ADDENDUM NUMBER TWO

DUPONT PUMP STATION AND BASIN IMPROVEMENTS – PHASE 2 (Contract B) W-12-026-203

CITY OF CHATTANOOGA, TENNESSEE

SHEET TITLE: CIVIL
YARD PIPING PROFILES I
 SHEET: C-2

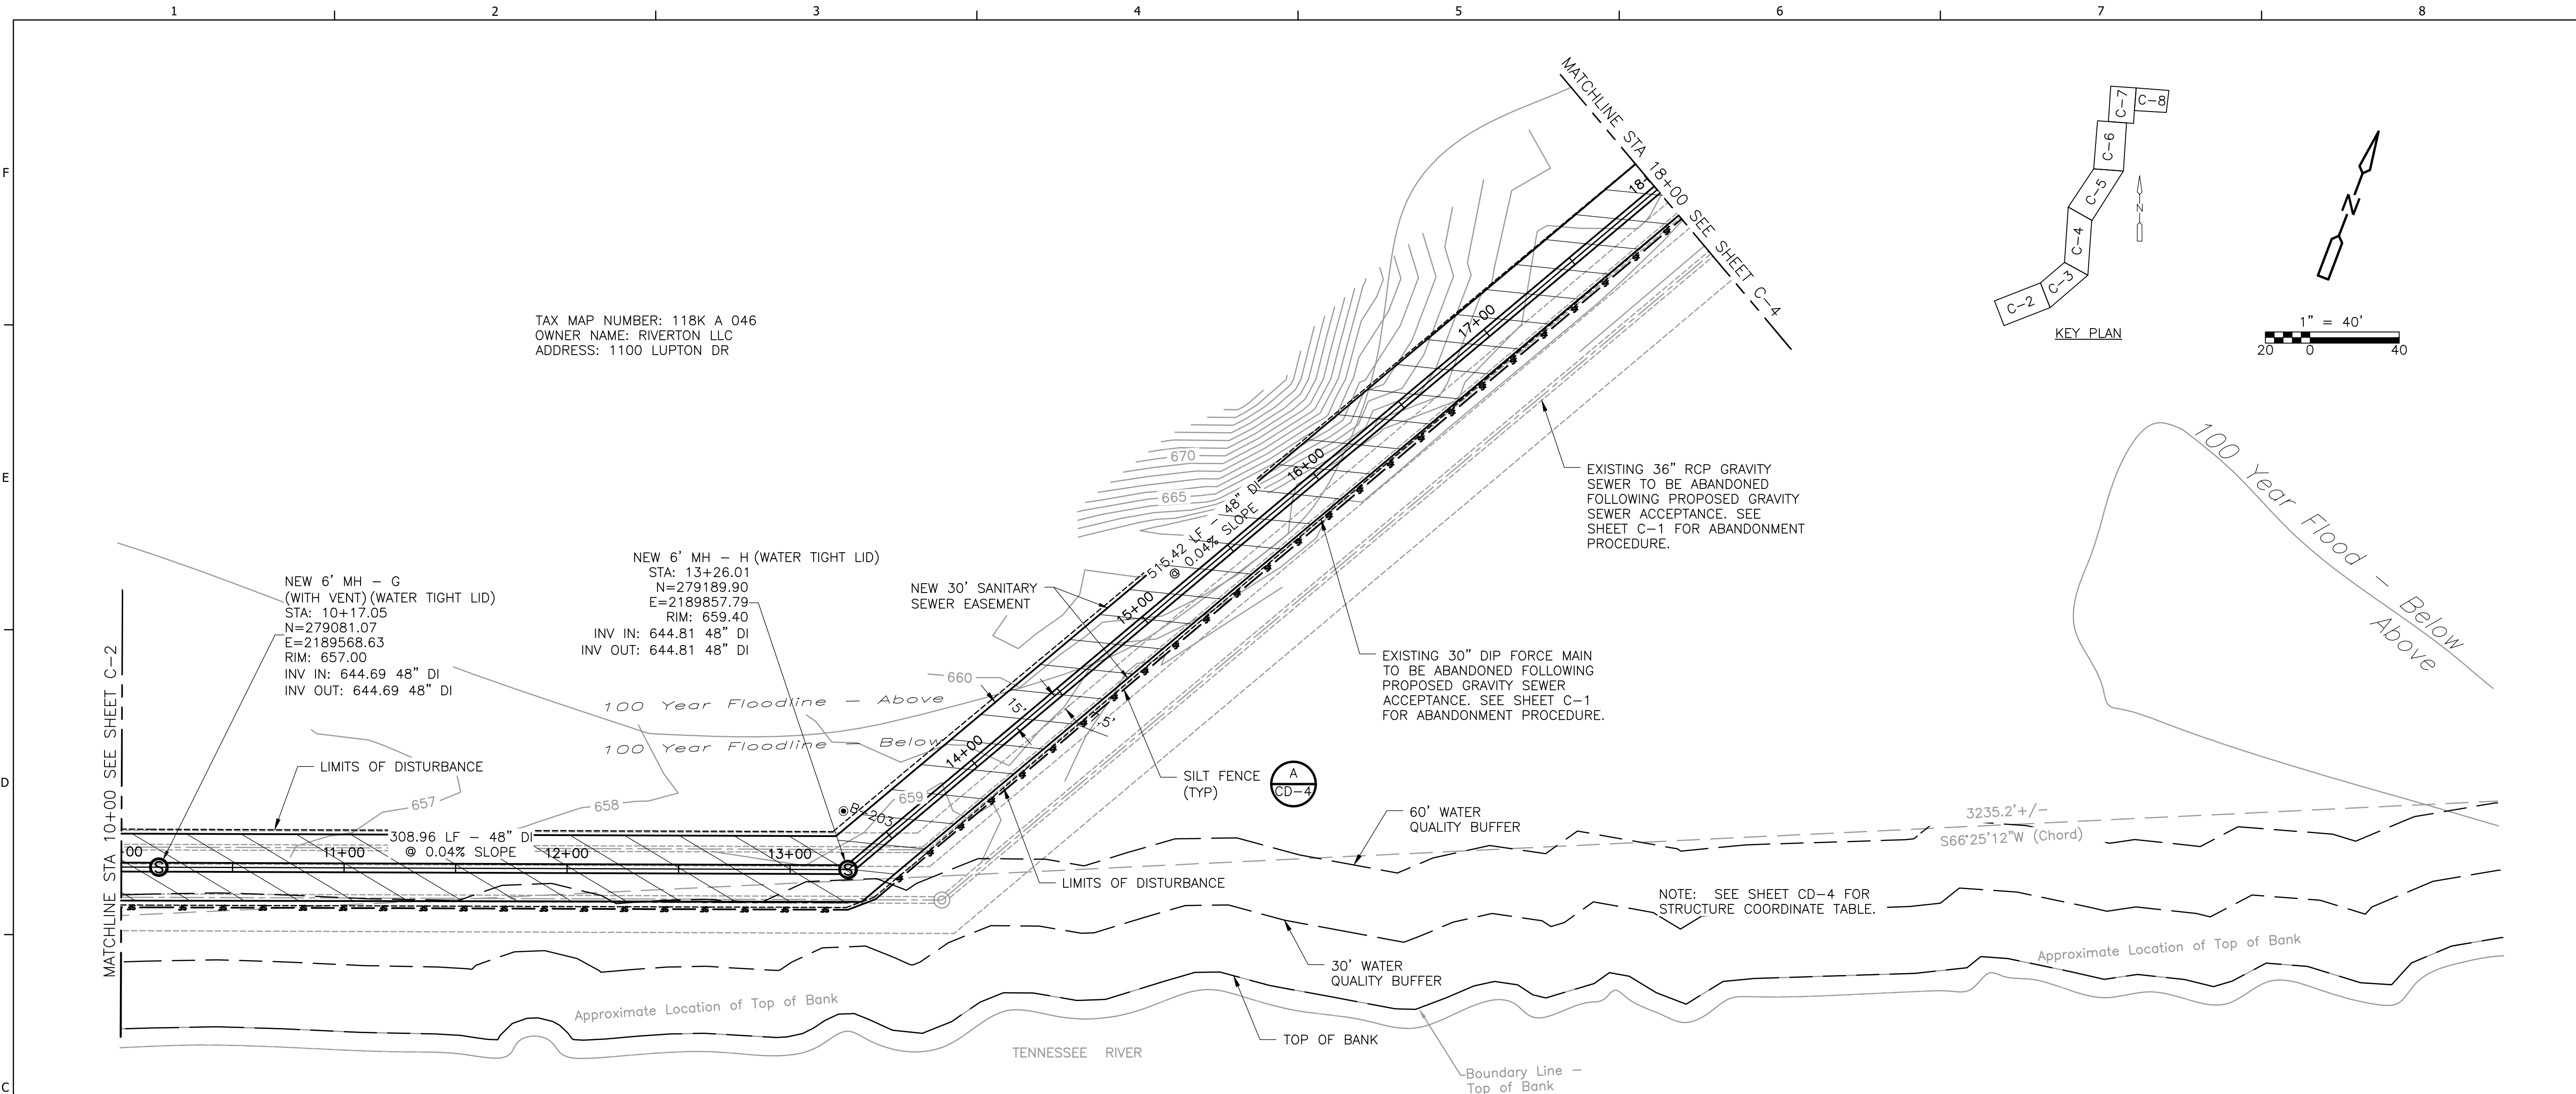
14. Reference Plan Sheet C-2. Approximate station 0+30. Can you confirm that the existing 30" FM is not in conflict with the proposed 48" GSM? If it is in conflict, how will the temporary relocation of the FM be paid? The same question applies at station 13+50, 54+10 and 60+00.

30. The plan sheets provided don't show on the profile the elevation of the existing pipes and structures that the 48" gravity sewer will be going through and/or over/under. Can these be added to the plans to know what will have to be taken out during the proposed sewer installation?

Response: The existing 30" FM is in conflict with the proposed 48" gravity sewer line at multiple locations. The contractor will be responsible for providing temporary bypass. See revisions included in this Addendum.

Response: The existing force main has been added to the profiles. See revisions attached to this addendum.

SHEET: C-3

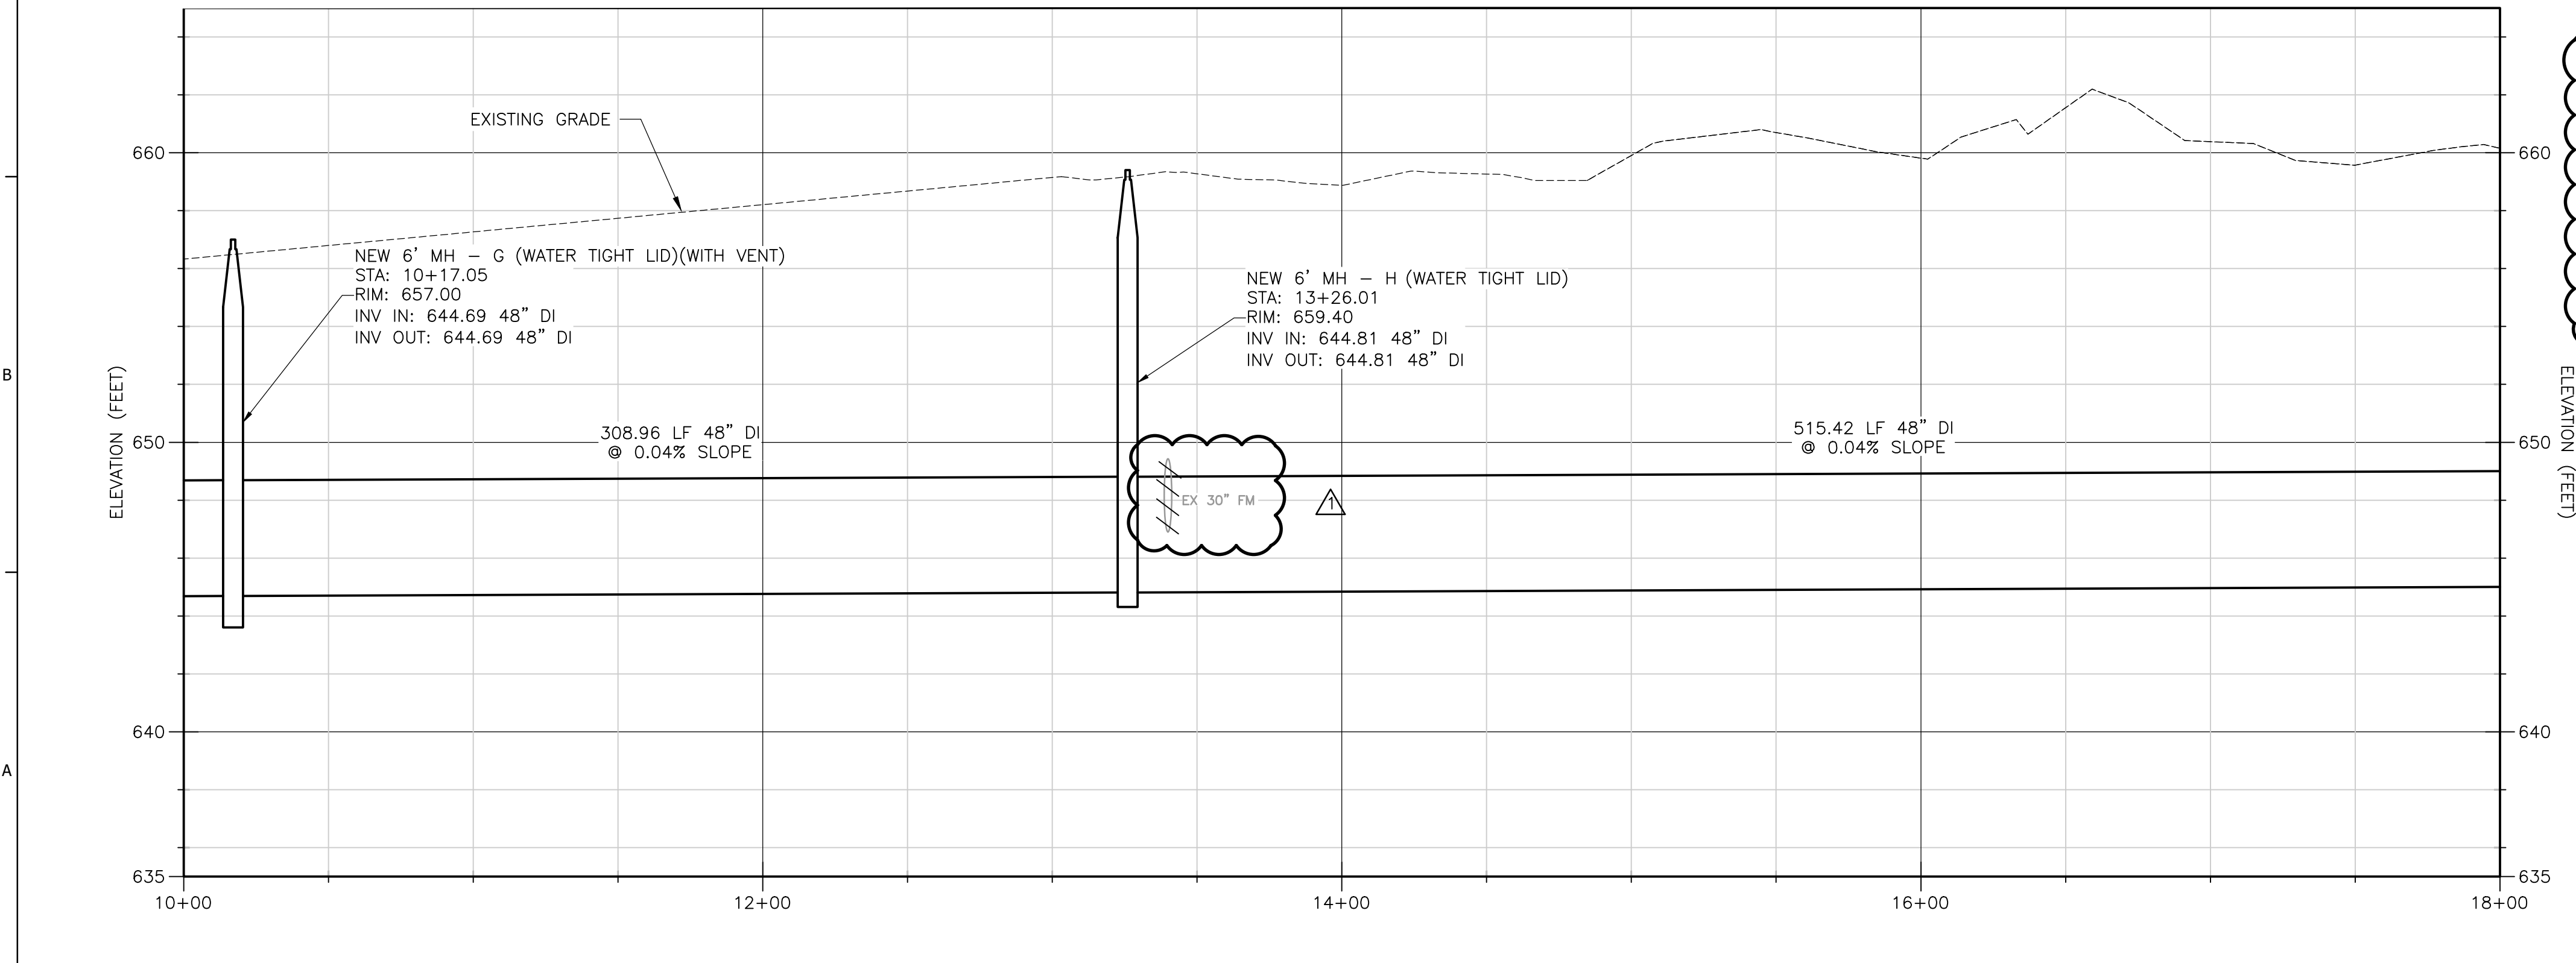
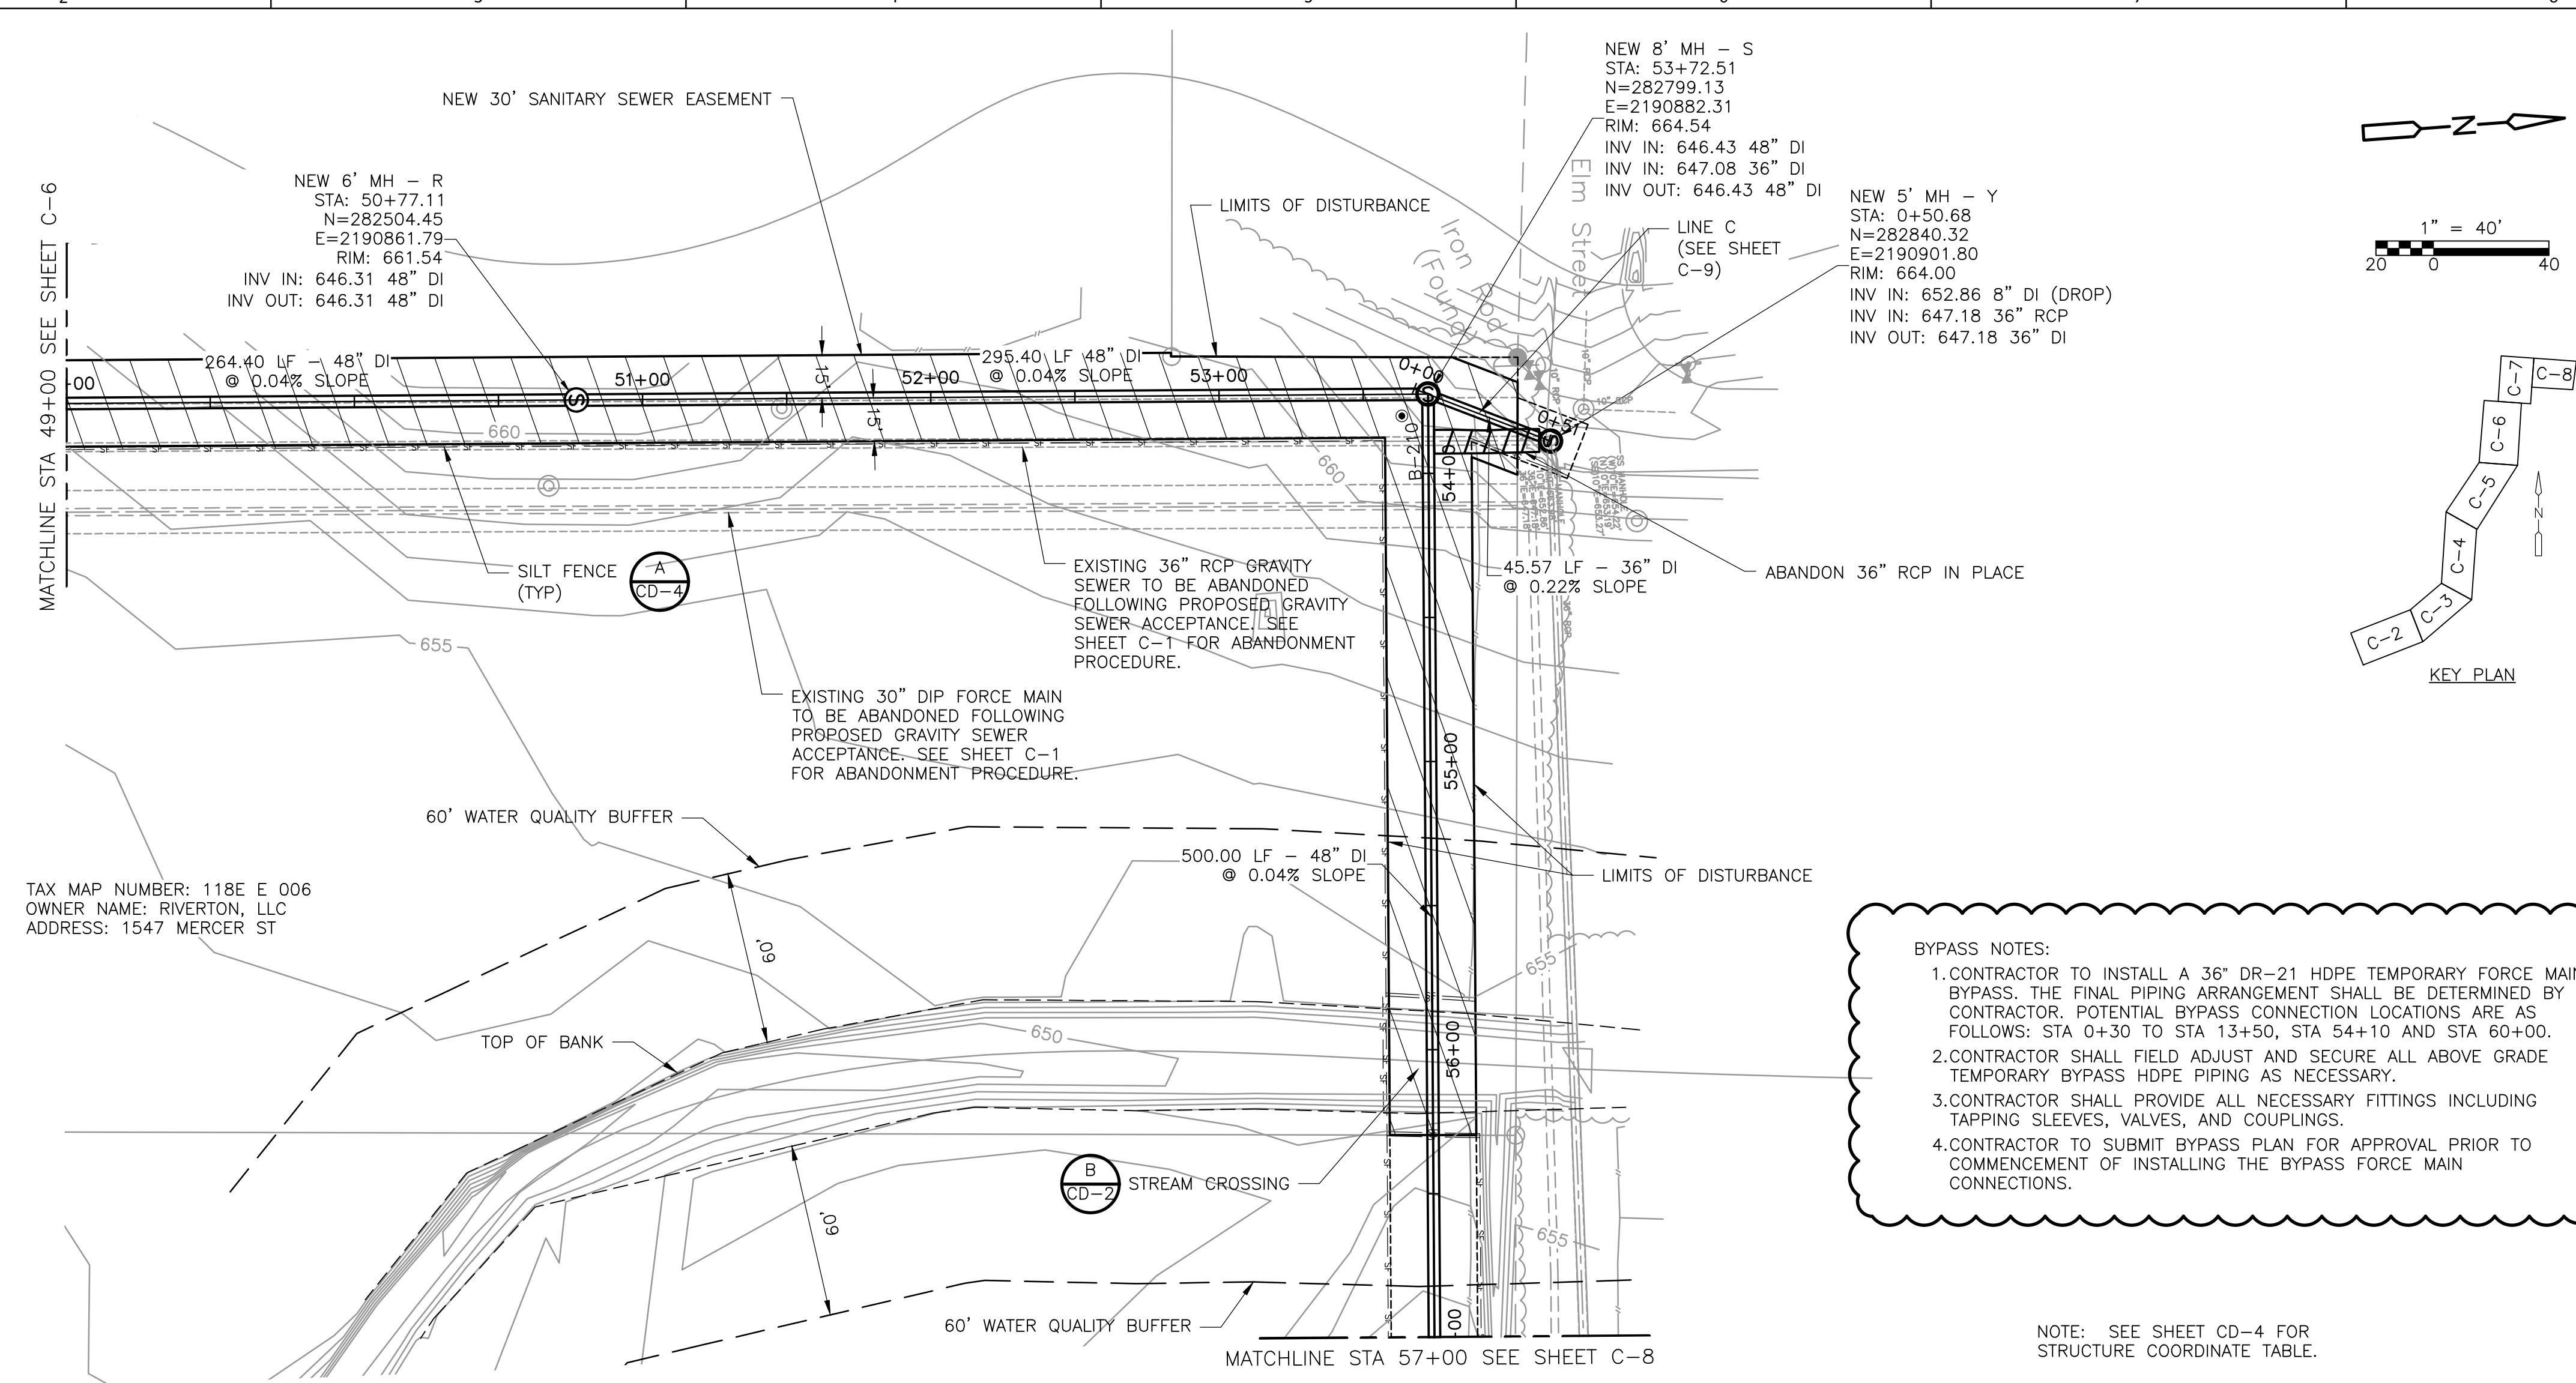
20. MH G on Sheet C-3 calls for a vent. Can you provide a detail for this work? How will it be paid?

Response: A detail has been added to the attached Sheet CD-6. The revised bid form is attached to Addendum No. 2.
